HYUNDAI
Technical Service Bulletin

NUMBER
25-EM-005H

MODEL(S)
SANTA CRUZ (NXT)

SUBJECT: INTEGRATED THERMAL MANAGEMENT (ITM)
REPLACEMENT & ECU SOFTWARE UPDATE – DTC P218100

ITM Replacement

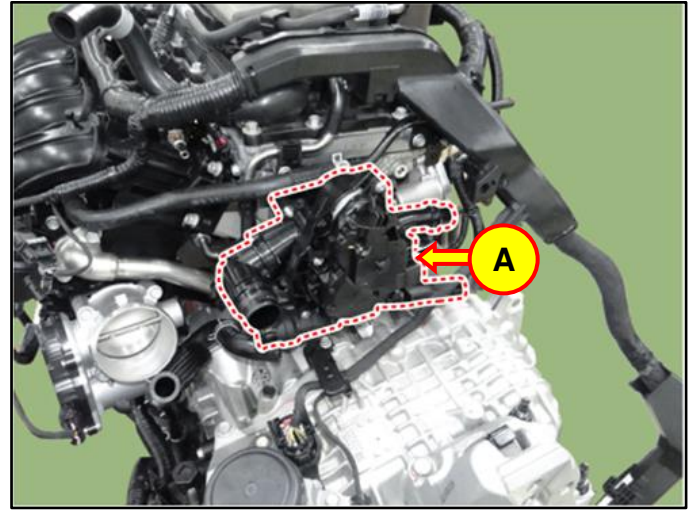
1. Utilize the GDS to detect DTC P218100:
Cooling System Performance:
 - If DTC P218100 is present, then replace the ITM (A) by referring to the shop manual.
 - **Engine Mechanical System > Cooling System > Integrated Thermal Management > Repair procedures**
 - If DTC P218100 is **NOT** present, then the service procedure is now complete.

Model	Part Name	Part Number		Quantity
Santa Cruz (NXT)	Integrated Thermal Management (ITM) Module	25600-2S600 (OLD)	25600-2S600QQH (NEW)	1
	Water Inlet O-Ring	25462-2S000		1
	Pink Coolant	00232-19098		2
